Service Bulletin

Bulletin No.: 17-NA-233

Subject: Malfunction Indicator Lamp (MIL) Illuminated - DTC P0446 Set

Brand:	Model:	Model Year:		VIN:		Engine:	Transmission:
		from	to	from	to		
Chevrolet	Cruze	2016	2019			1.4L (LE2)

4224572

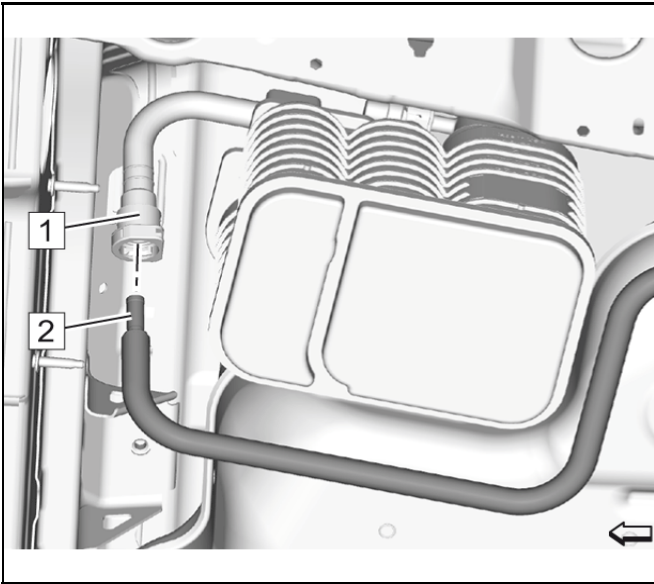
3. Using care, separate the evaporative emission canister filter pipe assembly retainers (2) from the vehicle and remove the assembly.

5443181

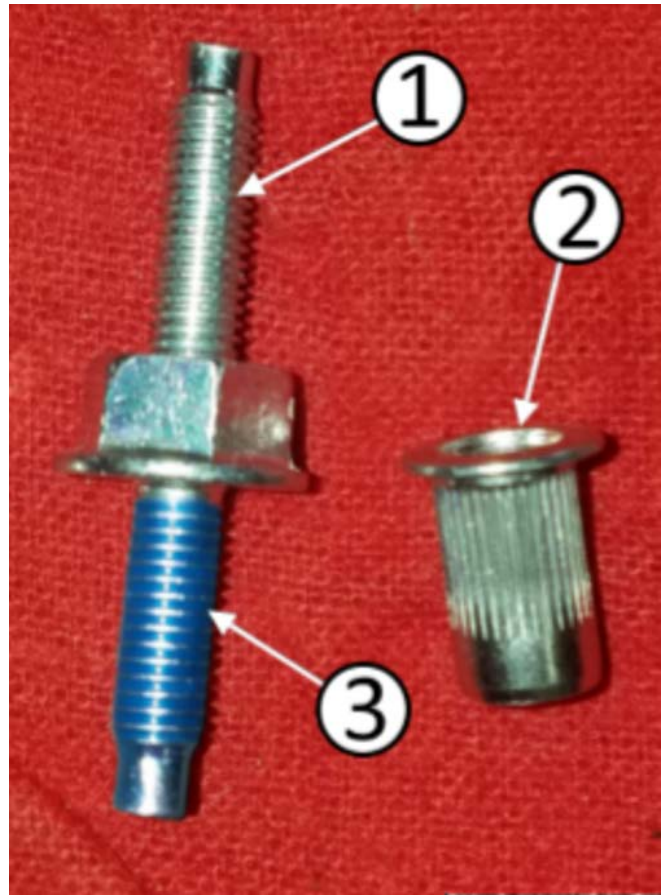
5. Install the new evaporative emission canister filter pipe (1), attaching the two lower clips to the existing studs (2).
6. Connect the evaporative emission canister filter pipe to the evaporative emission canister.
